Description of Permissive Change

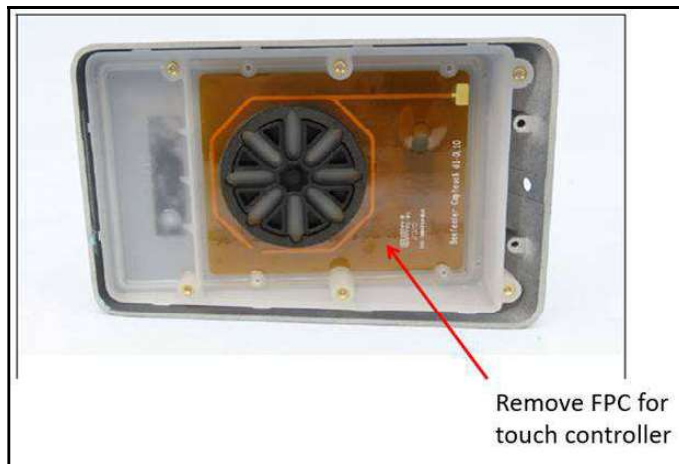
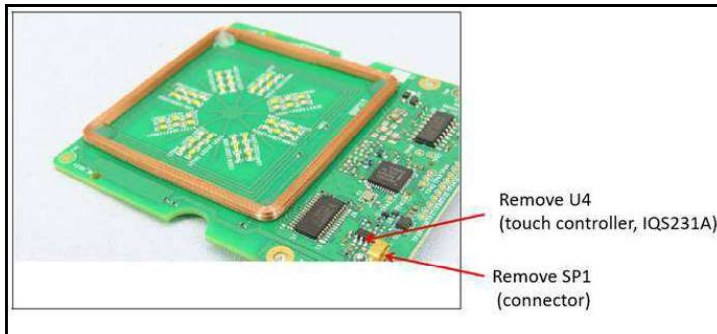
The application is prepared for FCC class II permissive change by removing capacitive touch feature including a controller(IQS231A) and FPC(Flexible Printed Circuit) sensing copper from its original parent application. More details please see the picture as below.
